Subject: **Addendum No. 2** to Building 1/36 (Parcel C) Source-Area Groundwater In-Situ Reactive Zone Pilot Study Workplan (Work Plan)
Request to Include Well WCC_06S as a Contingency Extraction Well
Former C-6 Facility, 19503 South Normandie Avenue, Los Angeles, California
File No. 95-036; SLIC No. 410; Site ID No. 1846000
Compliance File CI-9310, Order No. R4-2007-0040

Boeing Realty Corporation
Former C-6 Facility
Building 1/36 Biorecirculation
Pilot Study Well Layout

Figure 1

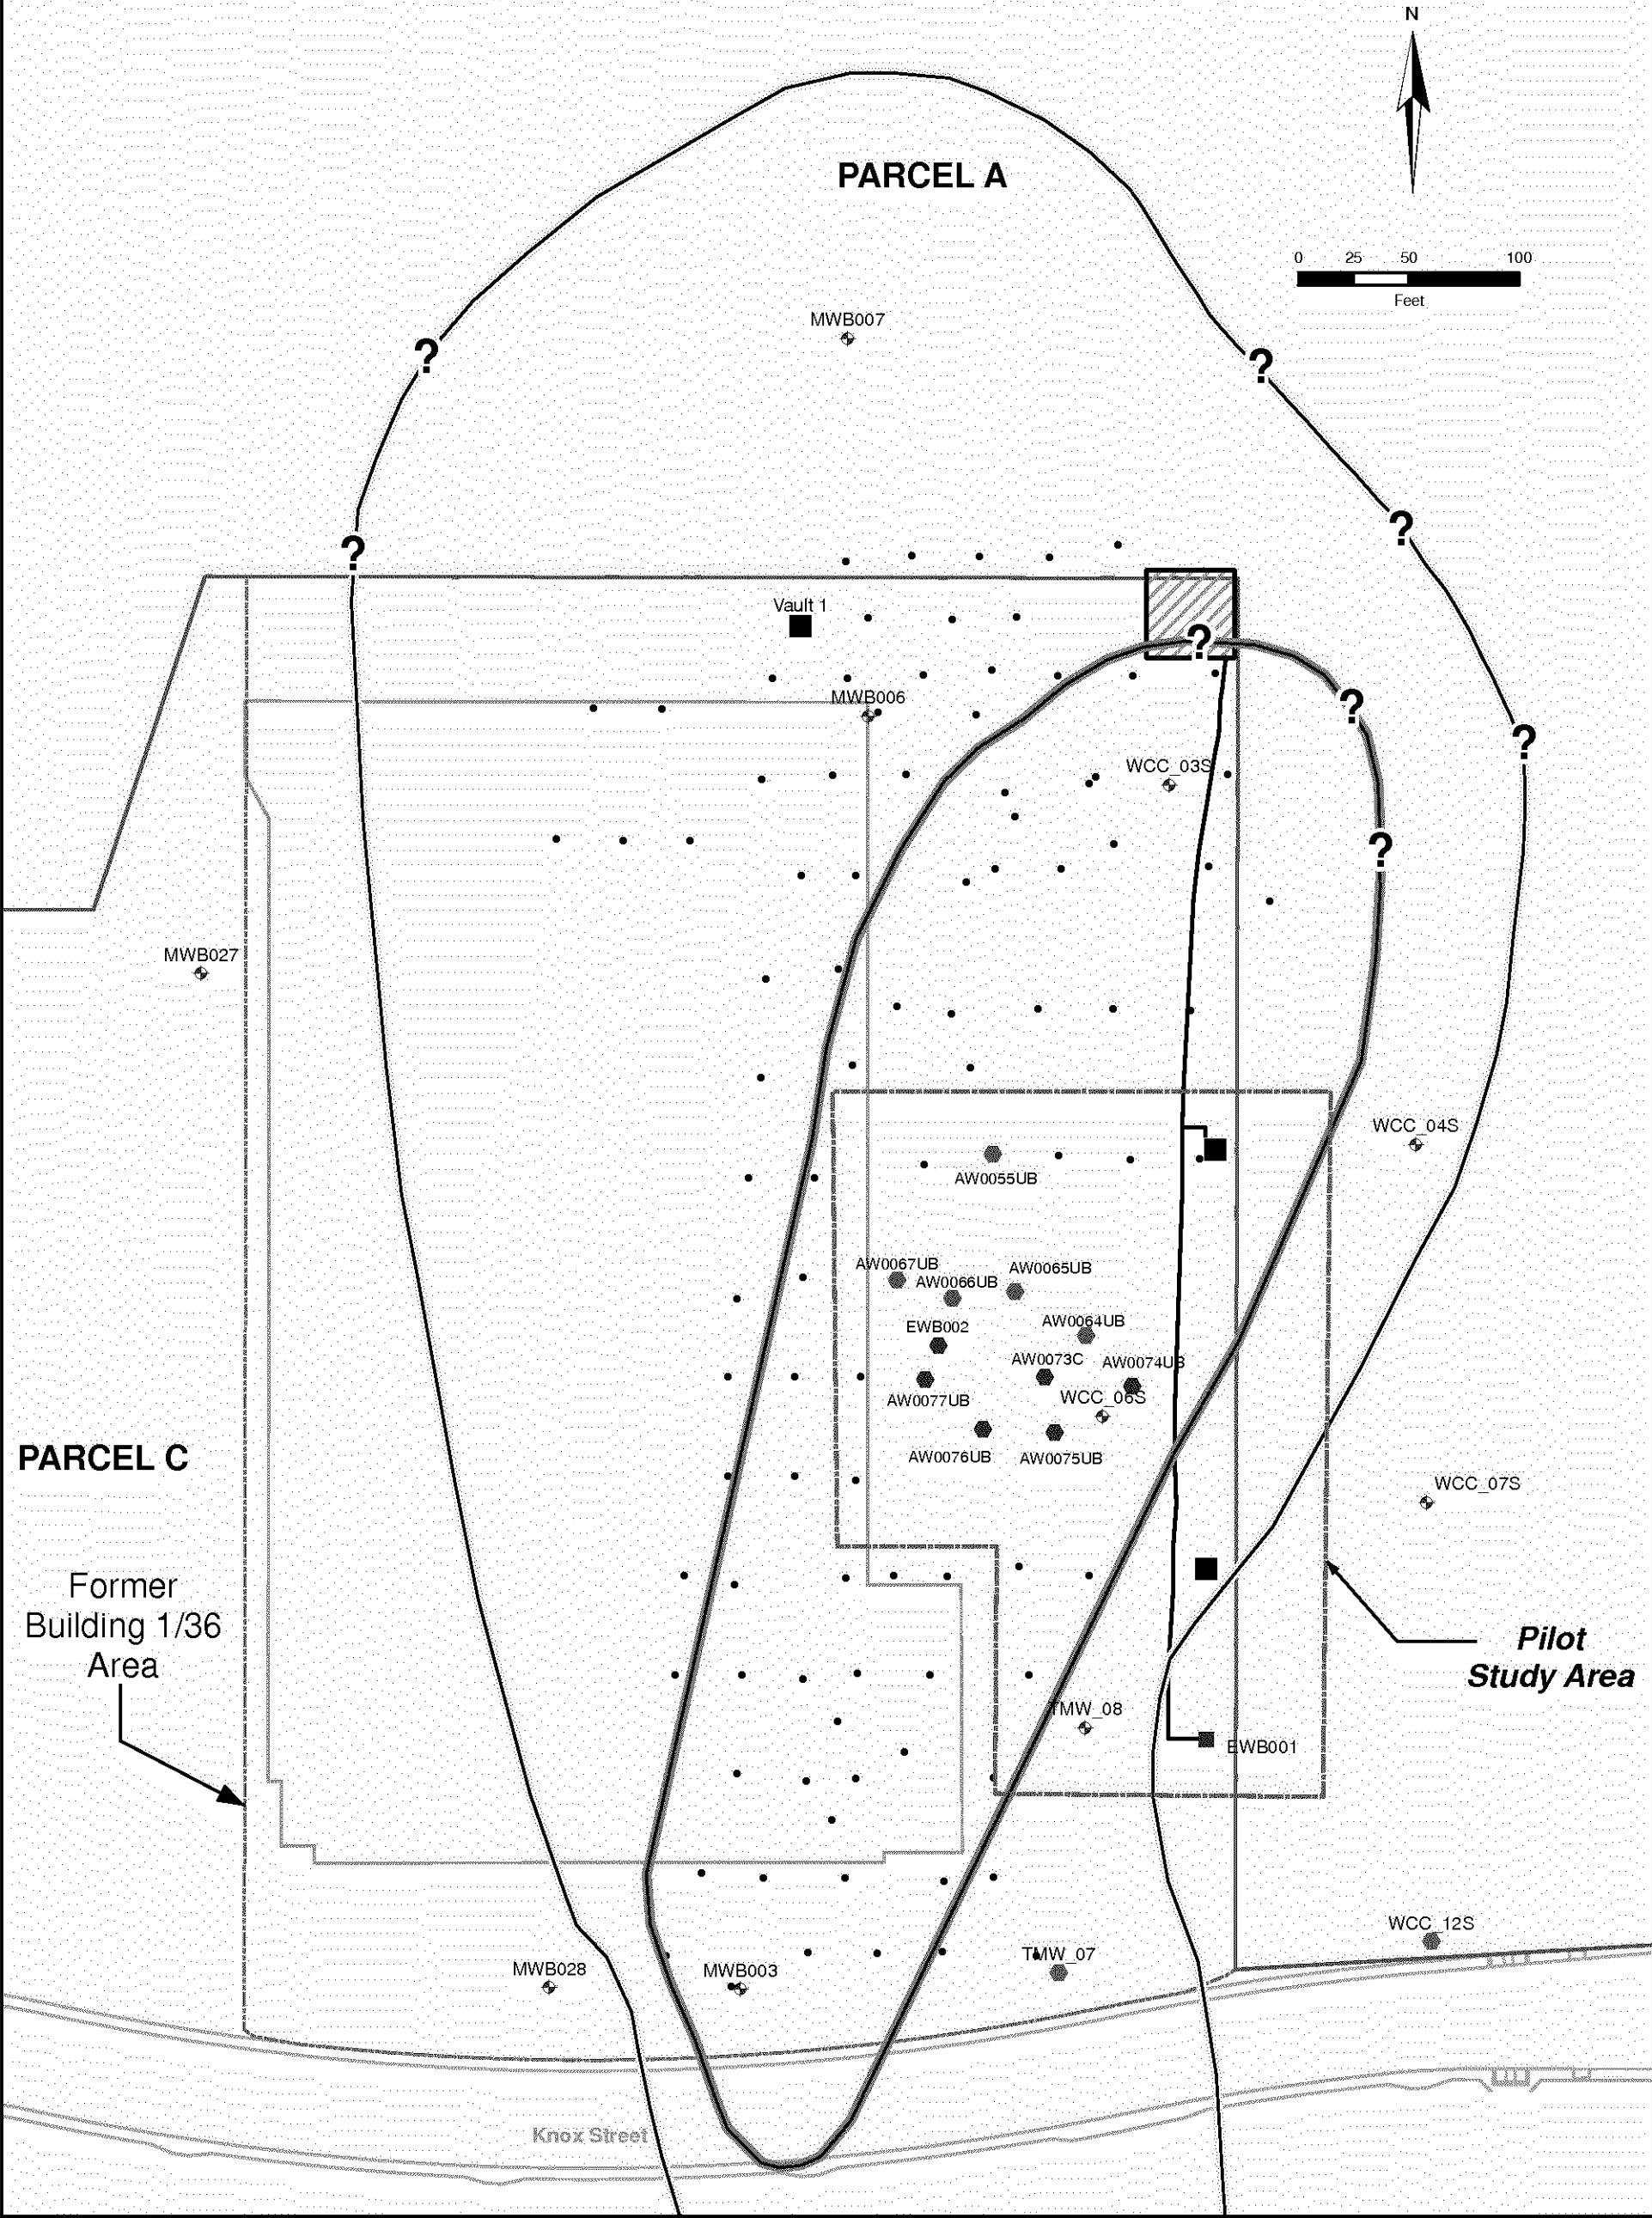
Performance Tests (APTs) at wells EWB001 and WCC_06S. These additional wells, including WCC_06S, were selected for testing to provide additional extraction wells besides EWB001, which was the only extraction well included in the Site-Specific WDR Permit. Well WCC_06S is one of the treatment zone performance monitoring wells (designated as Group B) proposed in the Monitoring and Reporting Program (MRP) under the Site-Specific WDR Permit (See attached Figure 1).

Based on the above-mentioned results, CDM is proposing to add well WCC_06S as a contingency extraction well for the biorecirculation pilot study. CDM believes that use of WCC_06S as a contingency extraction well is appropriate for the following reasons:

- Ability to provide supplemental ground water as needed to augment flow from well EWB001 for implementing the pilot study;
- Ability to act as a sole source of groundwater (if necessary) for the pilot study, in the event that well EWB001 does not perform as planned; and
- Optimal location of the well for the pilot study (i.e. downgradient of the injection wells and within the pilot study treatment zone).

CDM hereby requests permission from LARWQCB to allow use of WCC_06S as a contingency extraction well and proposes the following path forward for the pilot study.

- Start pilot study using well EWB001 at the flowrate of 5 gpm.
- Continue performance monitoring per the Site-Specific WDR Permit.
- Perform evaluation of the monitoring data on a continual basis during system operation to determine if the objectives of the pilot test (i.e. establishing proof-of-concept) are being met.

The results of the evaluation will determine whether or not to bring WCC_06S online. All extracted water from well WCC_06S, including the recently generated APT water from this well, will be treated through the pilot system prior to re-injection as required by the Site-Specific WDR Permit. In addition, the current MRP will not be affected by this Addendum, as WCC_06S will continue to be monitored and sampled per the MRP.
